Release Note

FTP MP3 V00.73

Firmware name:	FTP MP3 V00.73		
Released:	19. Jul. 2010		
Package name:	abcl_ftmp3_XXXX_v0073_20100719		
Version overview:	Type	File name	Version Date
	Firmware	abclw.rom	VA0.33_20100603
	WEB UI	abclapp.cob	V01.13_20100602
	FW Ext. 1	sg.bin	V08.10_20100719
	FW Ext. 2	fs.bin	VA2.05_20100113
	FW Ext. 3	bclio.bin	V01.14_20100421
	Bootloader	exfull.spb	V99.16_20100708
	ES Module	esnd.rom	V00.05_20091230

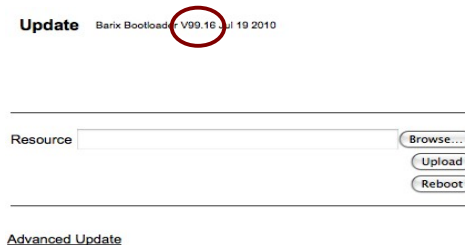
The following features have been removed (discontinued) starting from VA071, are valid also for V073:

- Receiving audio messages using the priority port is not possible anymore. The relevant configuration parameters (*PRIORITY_PORT*, *PRIORITY_VOLUME*, *PRIORITY_BUFFER*) are not supported anymore.
